**Year 1 Monitoring Report**

**MOCKINGBIRD SITE**

NCDMS Project # 100021 (Contract # 7185)

RE: Mockingbird Site: Year 1 Monitoring Report (NCDMS ID 100021)

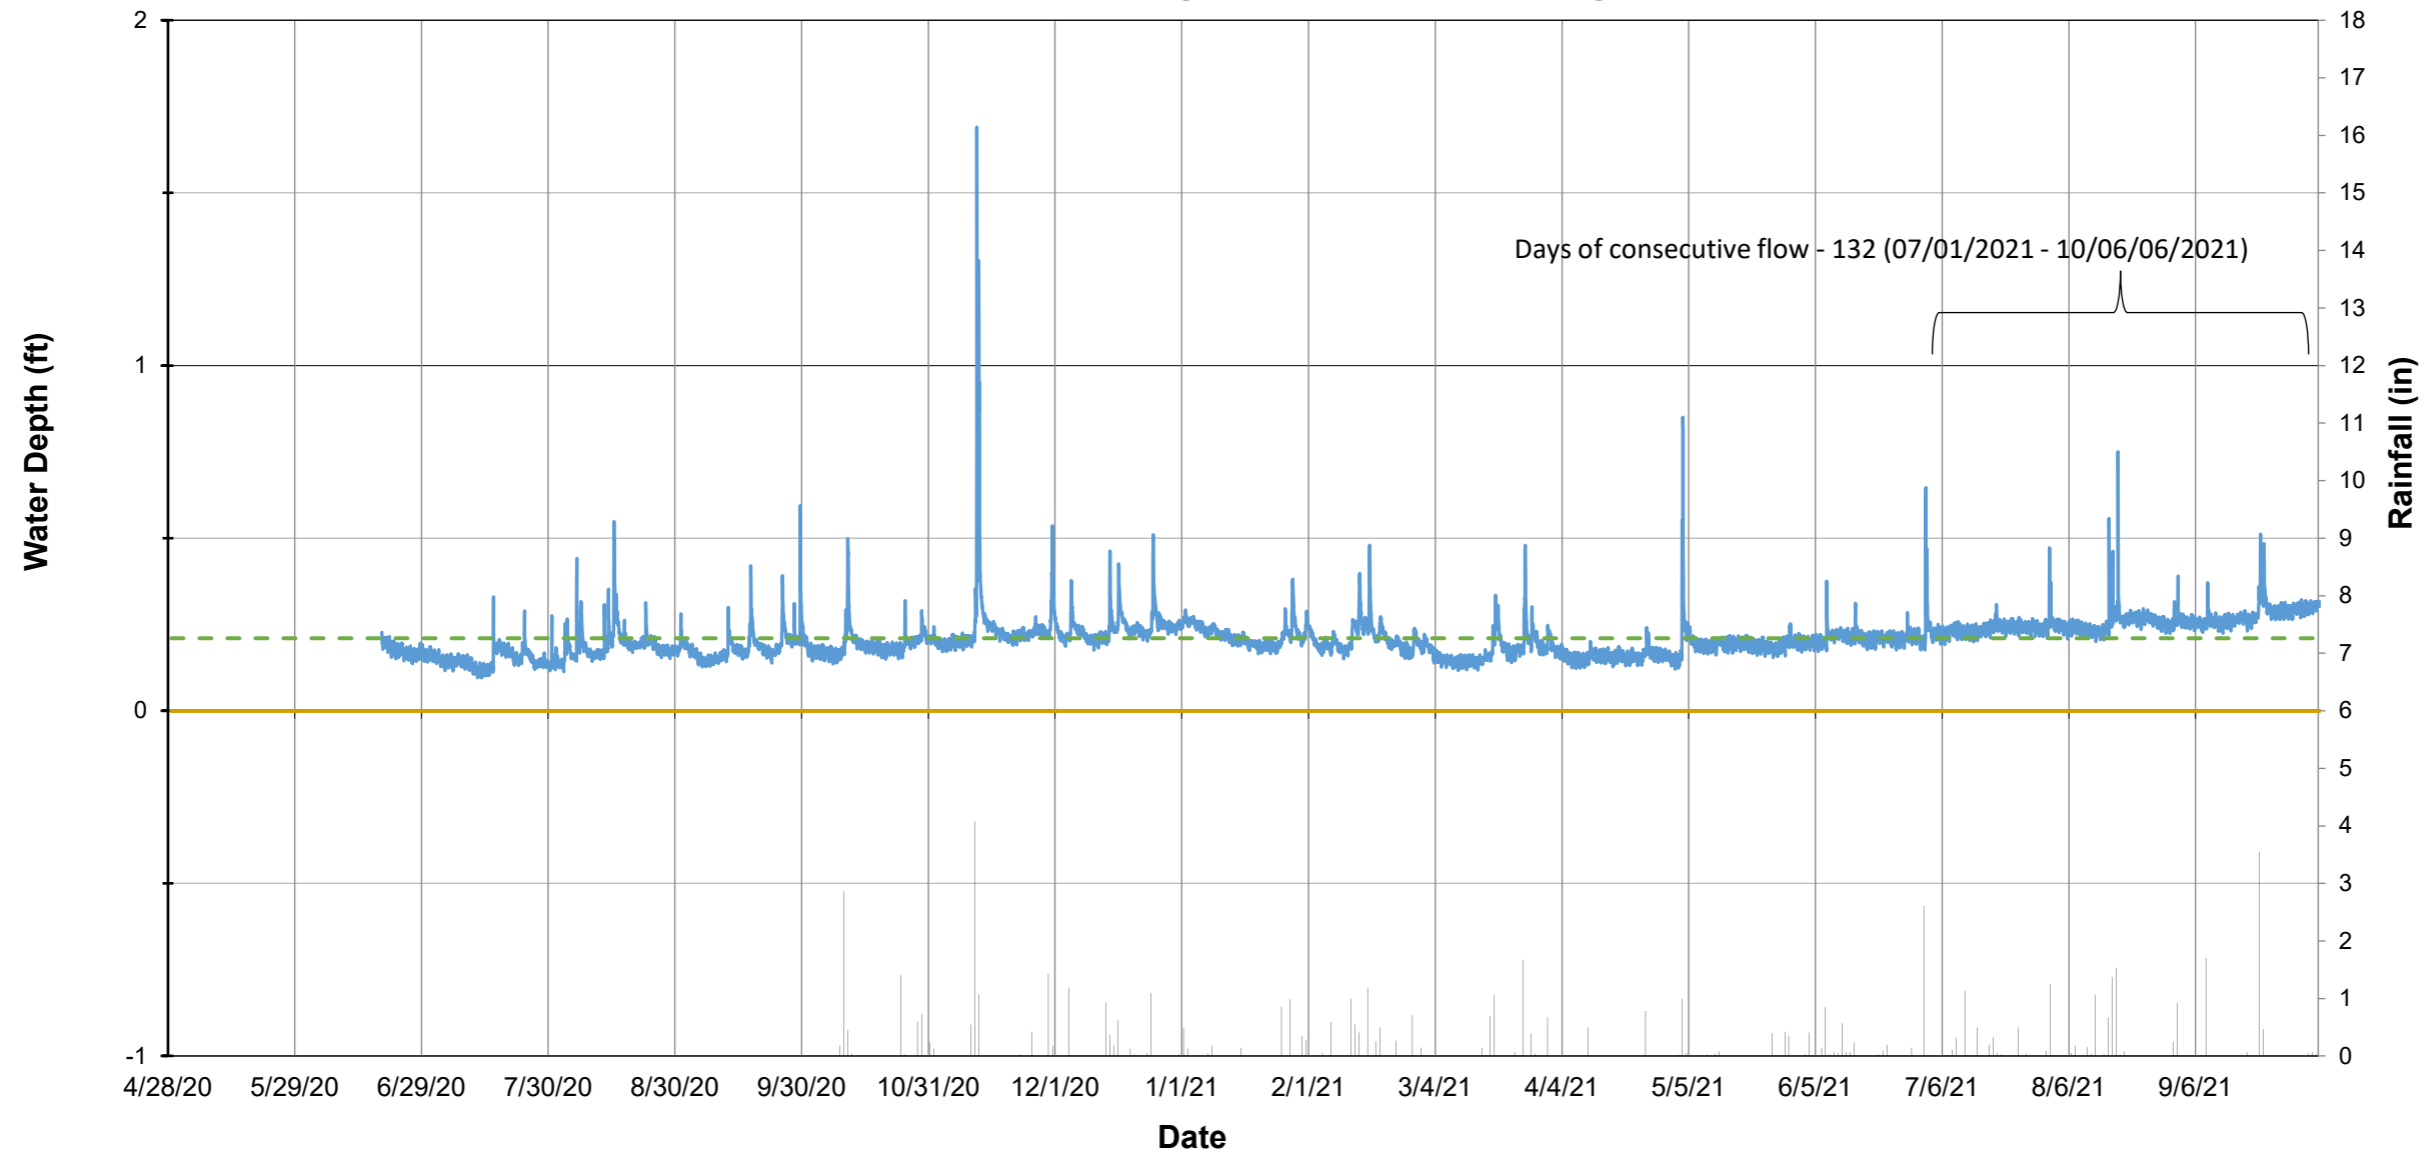
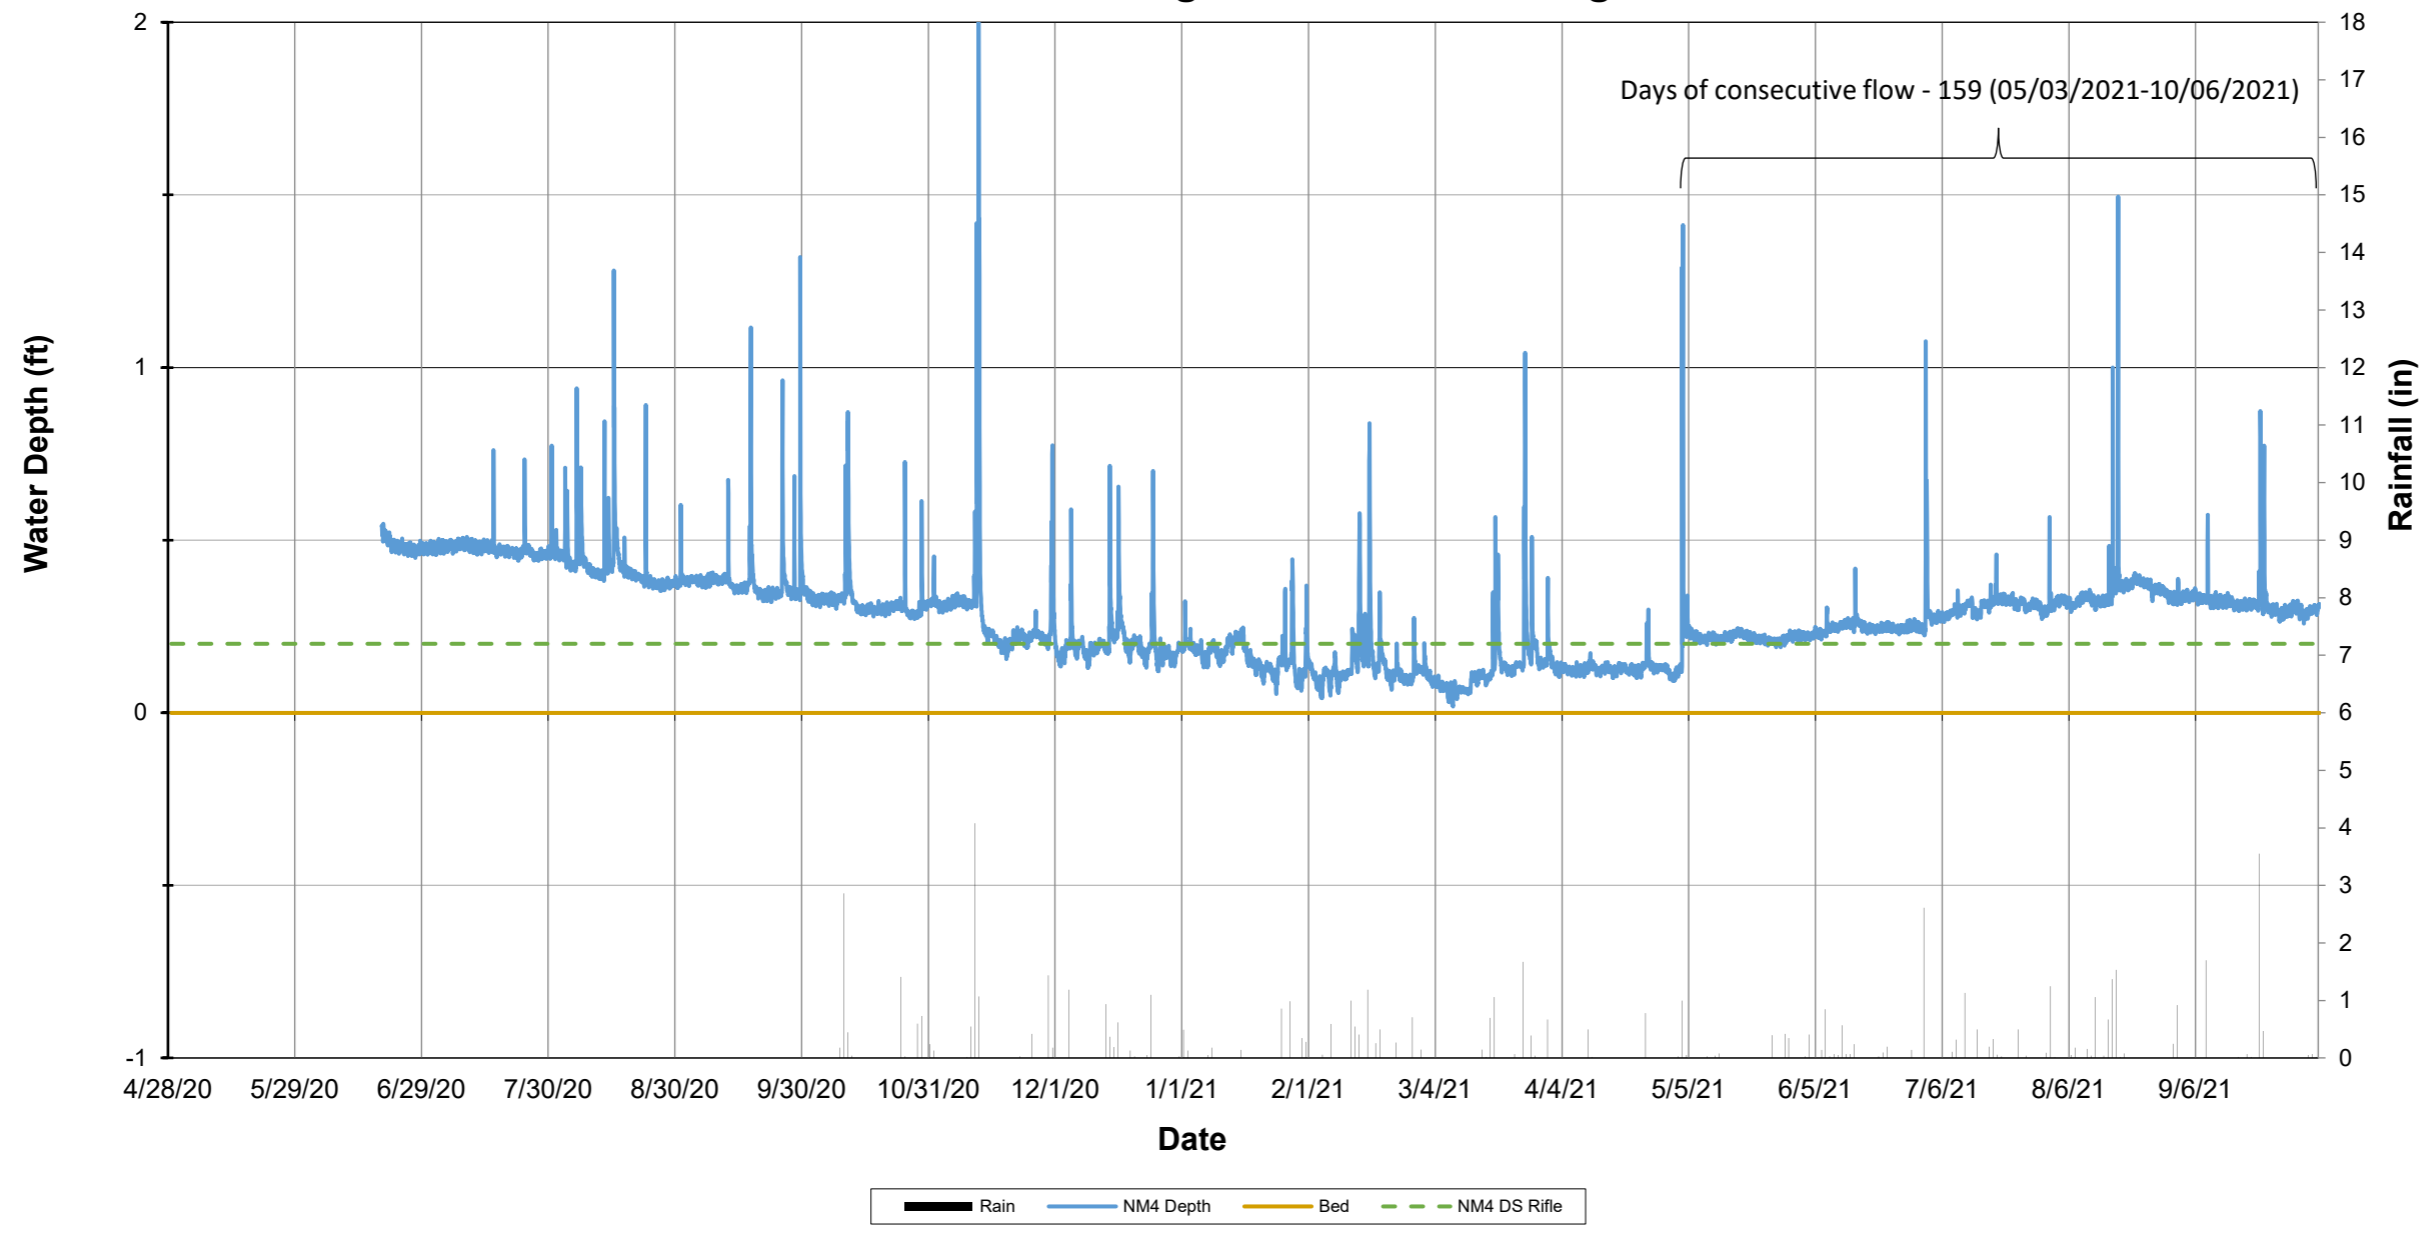
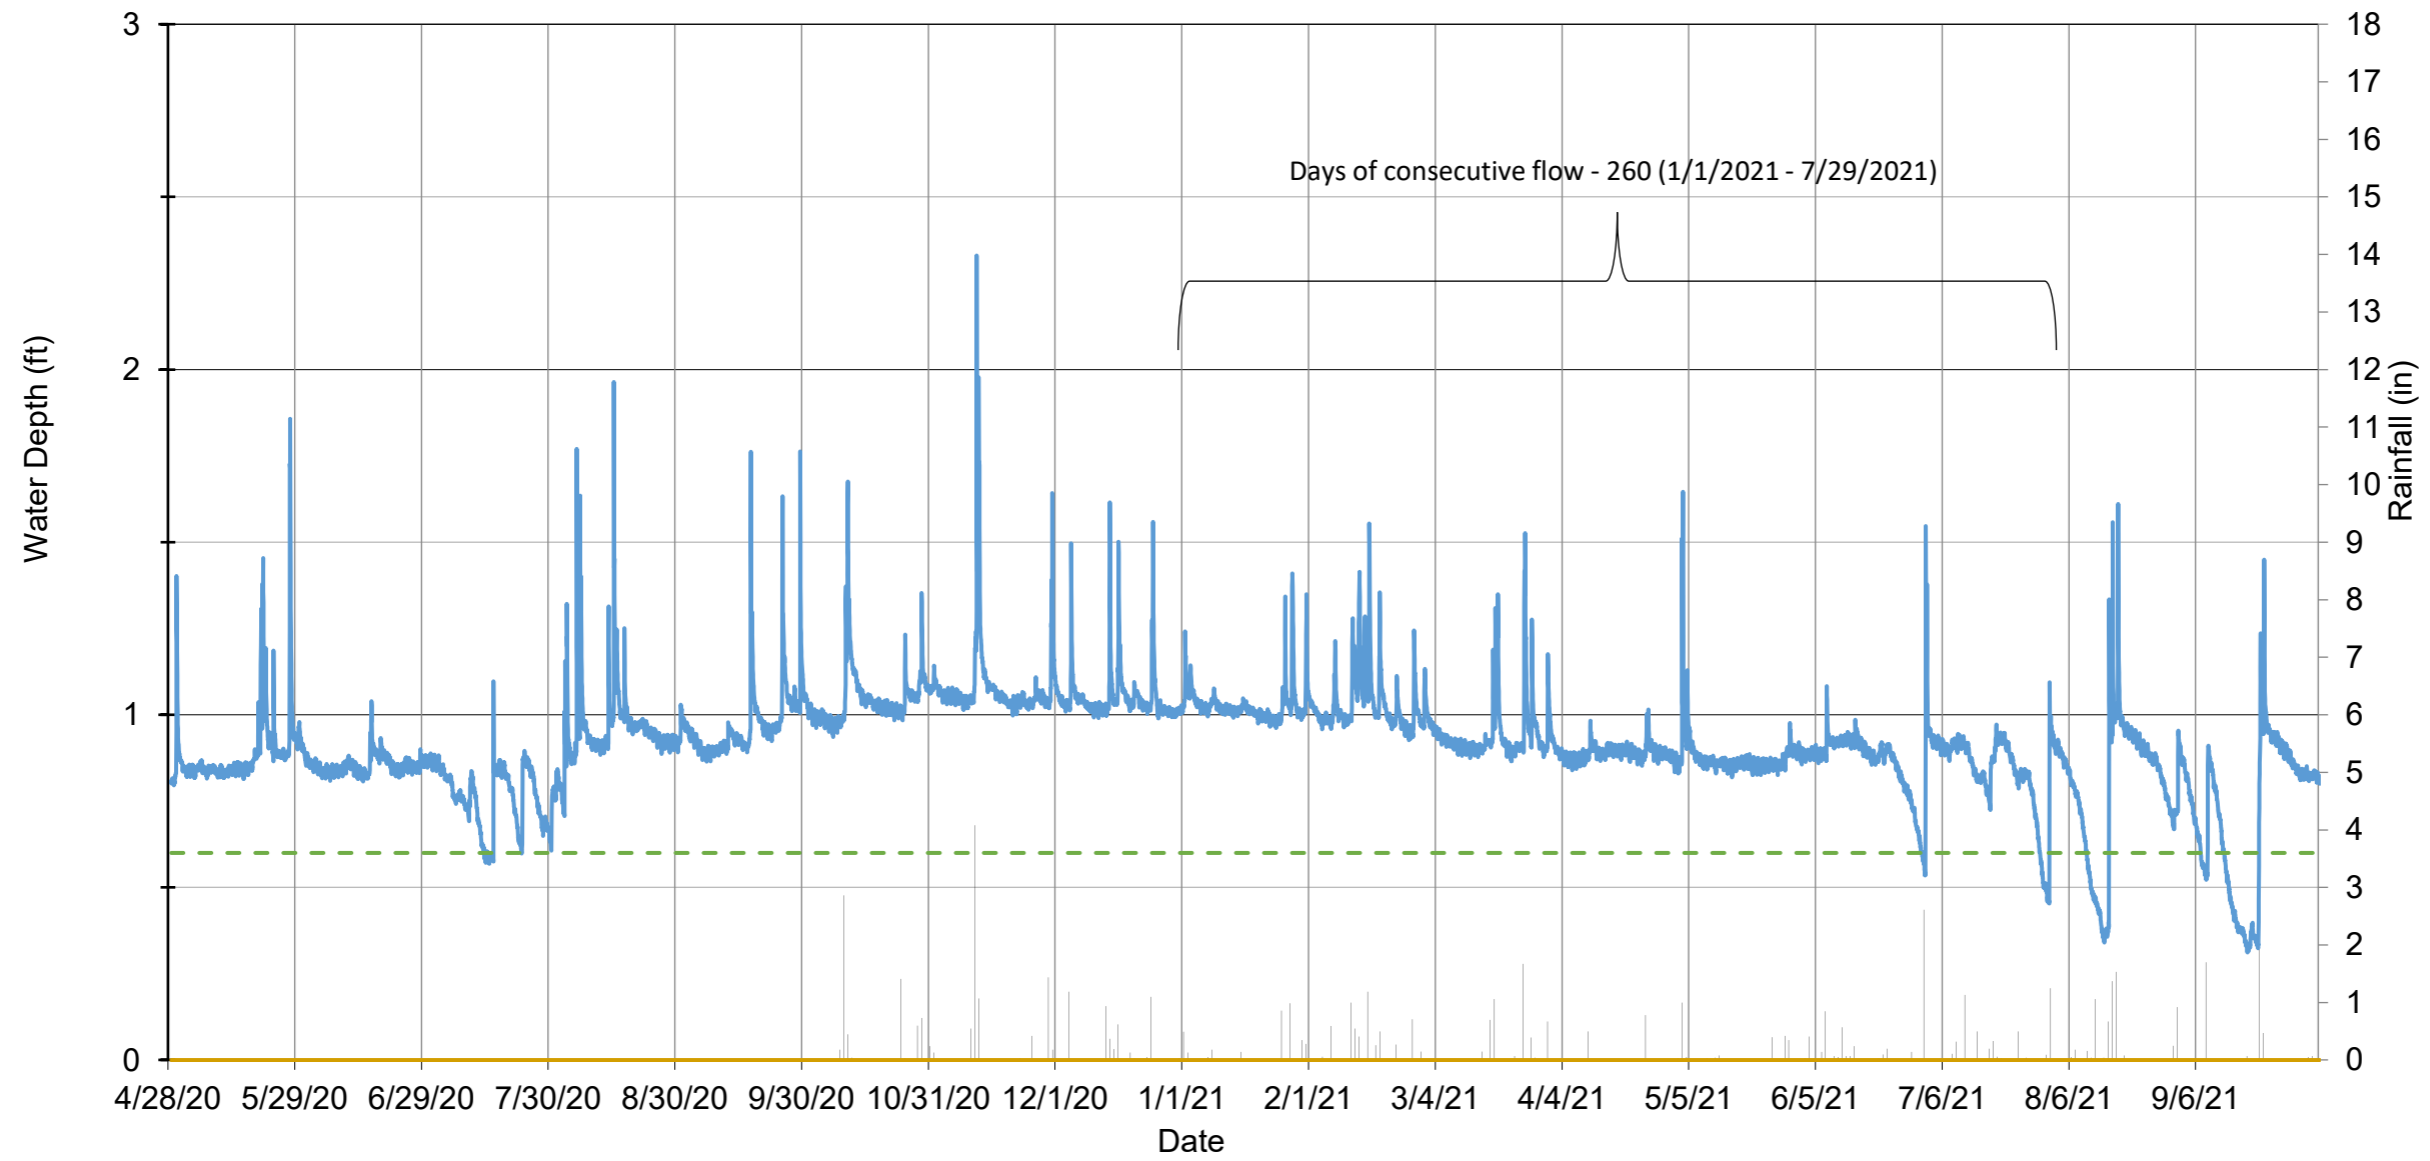
If possible, please indicate the consecutive days of flow on the flow gage graph, and show the corresponding period on the graph.

[Done. These are now included on the flow graphs.](#)
